THREE-PHASE TRANSFORMERS FOR 22 kV AND 33 kV 50 Hz DISTRIBUTION SYSTEMS

WITH ABILITY TO WITHSTAND SHORT CIRCUIT

Specification No. RTRN-035/2561

**เอกสารเพิ่มเติมแนบรายละเอียดสเปค 4
(ADDENDUM 4)**

ชนิดของหม้อแปลง	ตำแหน่งการพิมพ์
<p>(1) หม้อแปลง 3 เฟส ชนิด Conservator Type</p>	<div style="display: flex; justify-content: space-around; align-items: center;">   </div> <p>จุดพิมพ์หมายเลข PEA บริเวณส่วนล่างด้านหน้า และ ถังอะไหล่ของหม้อแปลง</p>

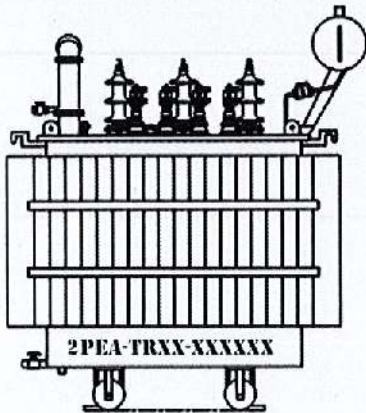
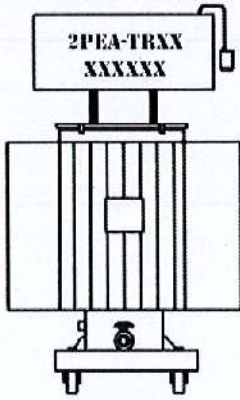
การพิมพ์หมายเลข PEA หม้อแปลง ตามข้อ 1c.13 Marking

ให้คู่สัญญาพิมพ์หมายเลข PEA หม้อแปลง ตามรายละเอียด ดังนี้

- (1) Font ของตัวอักษรและตัวเลข คือ **STENCIL**.
- (2) ความสูงของตัวอักษรและตัวเลข ไม่น้อยกว่า 3 นิ้ว
- (3) ตำแหน่งการพิมพ์หมายเลข PEA หม้อแปลง ดังนี้

ชนิดของหม้อแปลง	ตำแหน่งการพัน
<p>(4) หม้อแปลง 3 เฟส ชนิด Seal type แบบ 3D</p>	 <p>จุดพันหมายเลข PEA บริเวณครีبد้านหน้า และ ครีبد้านข้างของหม้อแปลง</p>

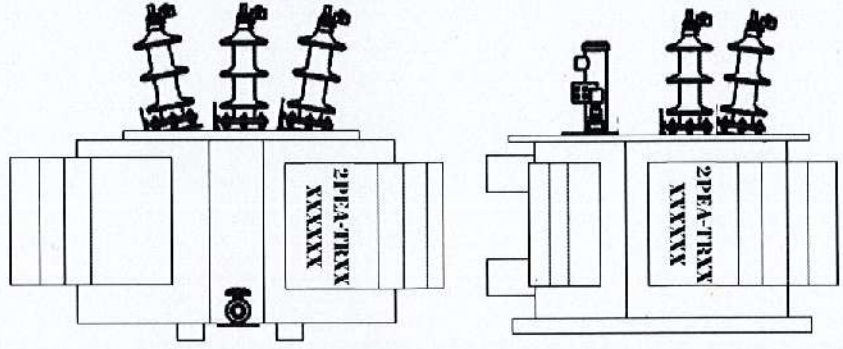
ในกรณีที่ไม่สามารถพันหมายเลข PEA ในจุดที่กำหนดได้ ให้สอบถามกองบริหารจัดการหม้อแปลงระบบจำหน่าย (กมล.) เพื่อกำหนดจุดพันที่เหมาะสม
